Department of Transportation

MEMORANDUM

SUBJECT: ZC Case No. 18-21 – 3135 and 3201 8th Street NE

Figure 1 – Site Plan (Source: CTR, Gorove/Slade, Figure 7, 3/8/19)

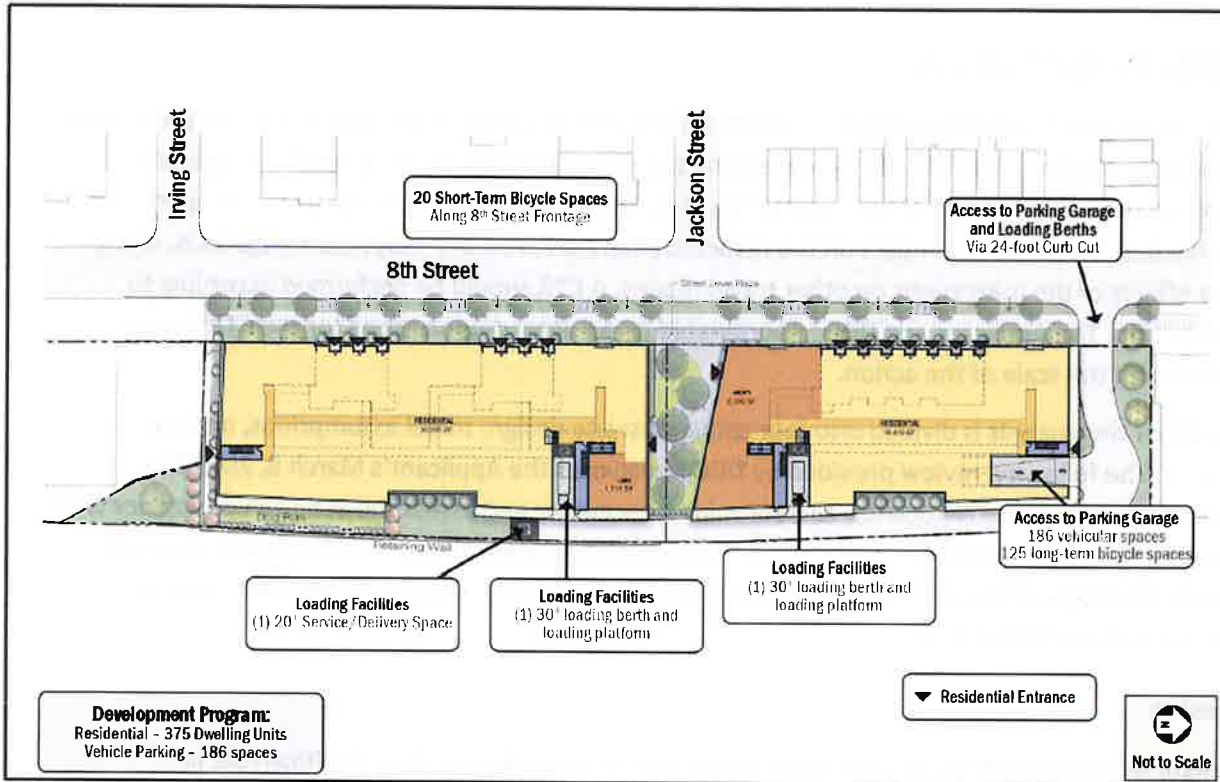
The proposed underground parking garage and above ground loading facilities will be accessed via a new 24-foot curb cut and two-way driveway at northwest edge of the site. Garage access is limited to the north building, however the one-level underground garage spans the footprint of both buildings and both buildings will have access to the garage. The driveway continues along the eastern frontage of the site to provide access to above ground loading facilities for each building and a shared delivery space on the eastern edge of the site.

The development is proposed to have multiple pedestrian entrances off of 8th Street NE. A majority of residents will access the site from two separate entrances off of the outdoor plaza, which bisects the north and south buildings. There will also be additional entrances off of 8th Street NE that provide access to individual units that face 8th Street NE. Bicycle access to the site will primarily be along 8th Street, which provides access to long-term parking in the garage, through the driveway entrance via 8th Street NE, and short-term parking curbside parking along 8th Street. Figure 1 below shows the proposed site layout.

While the preliminary public space plans are generally consistent with DDOT standards, there are several considerations that need to be incorporated and items to be reviewed in greater detail during the public space permitting process:

- There are two (2) curb cuts proposed to be closed on 8th Street NE;
- The walkway crossing the site's driveway should be raised and flush with existing sidewalk 8th Street NE;
- Determine final locations for the 20 short-term bicycle spaces (10 inverted U-racks) in easily accessible locations, near building entrances, and preferably within the 'furniture zone' near the curb;
- All other public space elements such as crosswalks, curb ramps, step projections, lead walks, roof overhangs, special paving, street trees, and benches will be subject to public space approval.

Figure 7 – Existing Pedestrian Infrastructure (Source: CTR, Gorove/Slade, Figure 37, 3/8/19)

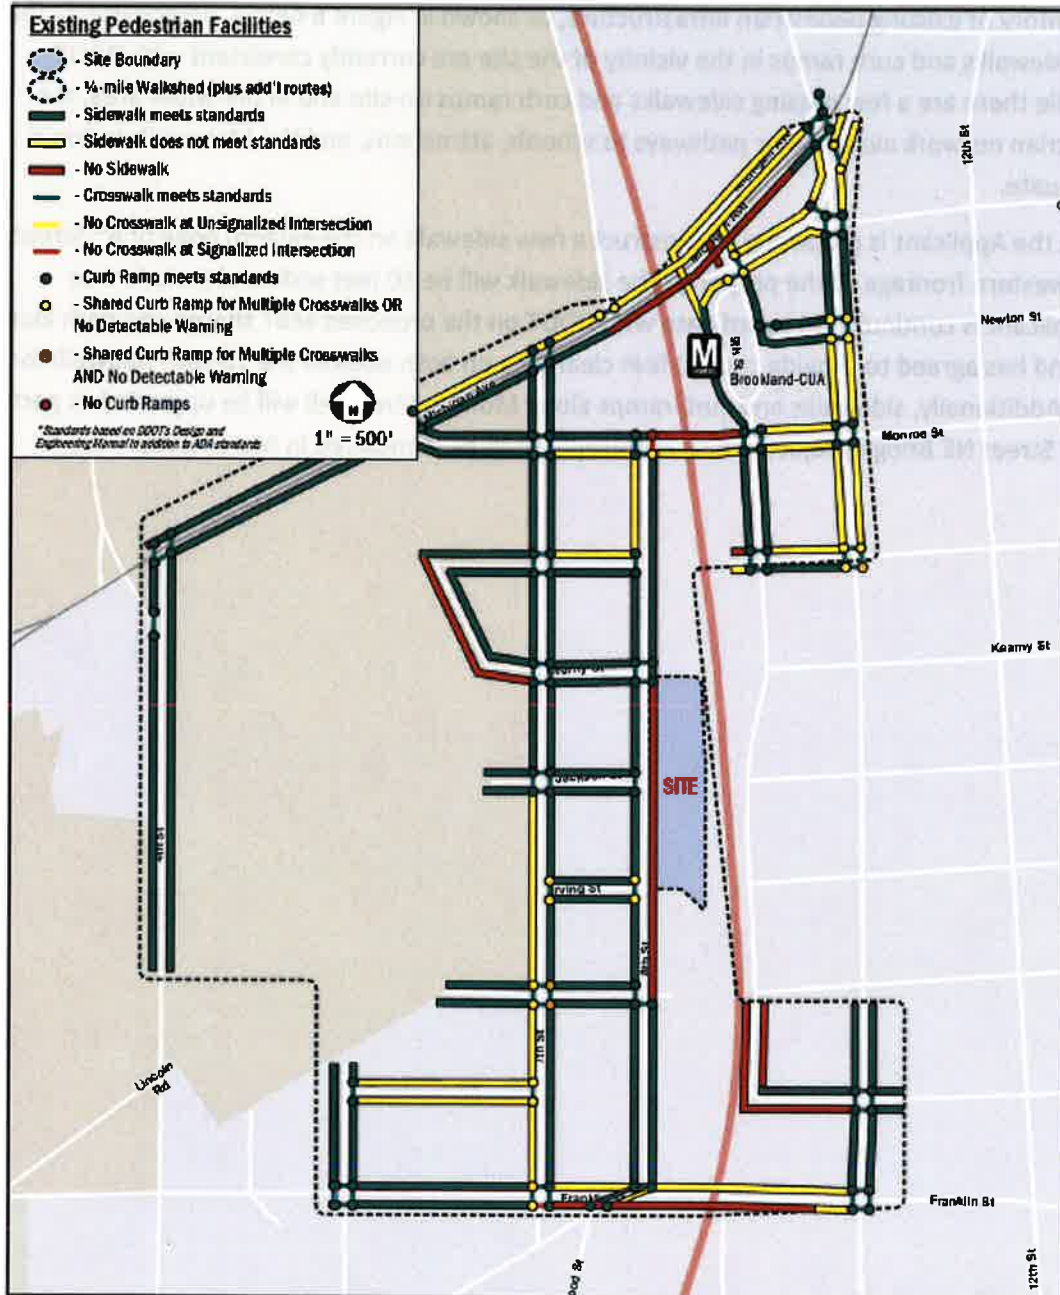
The CTR's inventory of existing pedestrian infrastructure, as shown in Figure 6 below, demonstrates that a majority of sidewalks and curb ramps in the vicinity of the site are currently consistent with DDOT standards. While there are a few missing sidewalks and curb ramps on-site and in the wider area, the existing pedestrian network along major pathways to schools, attractions, and the Metrorail station is generally adequate.

It is noted that the Applicant is proposing to construct a new sidewalk on the eastern edge of 8th Street NE, along the western frontage of the property. The sidewalk will be 10 feet wide and include tree boxes. The Applicant is continuing to coordinate with DDOT on the proposed MBT shared-use path along 8th Street NE and has agreed to provide two (2) feet clearance on both sides of the 10-foot sidewalk for future design. Additionally, sidewalks and curb ramps along Monroe Street NE will be upgraded as part of the Monroe Street NE Bridge project, which is anticipated to be completed in March 2019.

Figure 8 – Existing and Proposed Bicycle Facilities (Source: CTR, Gorove/Slade, Figure 39, 3/8/19)

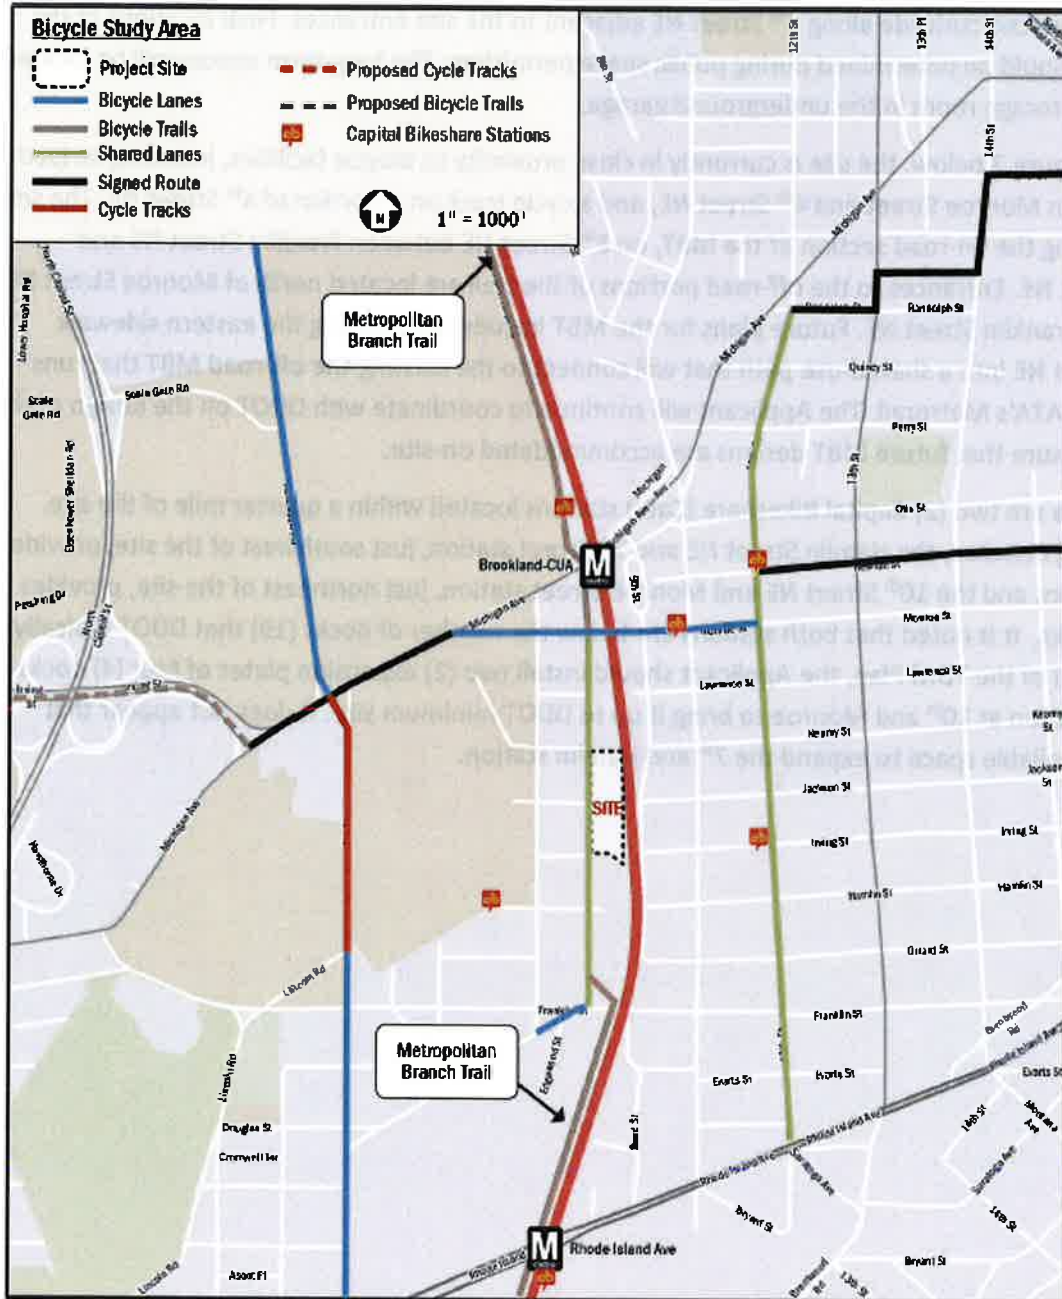
As shown in Figure 7 below, the site is currently in close proximity to bicycle facilities, including striped bicycle lanes on Monroe Street and 4th Street NE, and a cycle track on a portion of 4th Street NE. The site is situated along the on-road section of the MBT, on 8th Street NE between Franklin Street NE and Monroe Street NE. Entrances to the off-road portions of the trail are located north of Monroe Street NE and south of Franklin Street NE. Future plans for the MBT include repurposing the eastern sidewalk along 8th Street NE into a shared-use path that will connect to the existing the off-road MBT that runs alongside WMATA's Metrorail. The Applicant will continue to coordinate with DDOT on the design of the sidewalk to ensure that future MBT designs are accommodated on-site.

Currently there are two (2) Capital Bikeshare (CaBi) stations located within a quarter mile of the site. Within walking distance, the Hamlin Street NE and 7th Street station, just southwest of the site, provides 15 bicycle docks, and the 10th Street NE and Monroe Street station, just northeast of the site, provides 11 bicycle docks. It is noted that both stations are below the number of docks (19) that DDOT typically installs. As part of the TDM Plan, the Applicant should install two (2) expansion plates of four (4) docks each to the station at 10th and Monroe to bring it up to DDOT minimum size. It does not appear that there is any available space to expand the 7th and Hamlin station.
